IOPMP Task Group Meeting September 28, 2023

Minutes

The first entry of MD is TOR

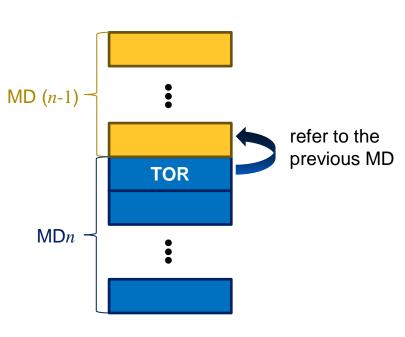
When the first entry of a MD is TOR, the regions of the entry will be affected by the previous MD.

To prevent accidentally reference, A notice should be added in spec:

- If one doesn't want the entry referring to the previous MD → avoid using the first entry as TOR.
- If one doesn't want the entry referred by the following MD → add an OFF entry with the last address in the last entry.
- The last address is supposed to be all 1's in all programmable bits.

Suggestion: for MD *n*

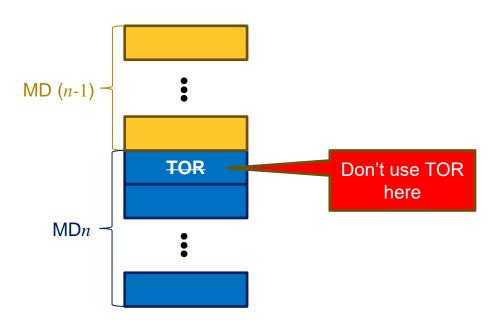
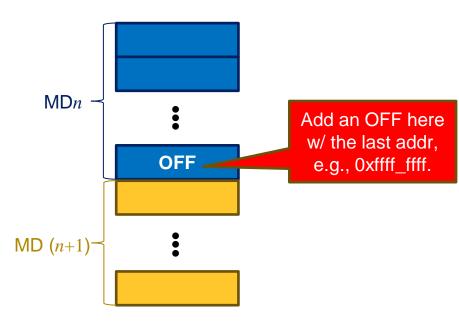
To prevent MD*n* from being referred by the next MD
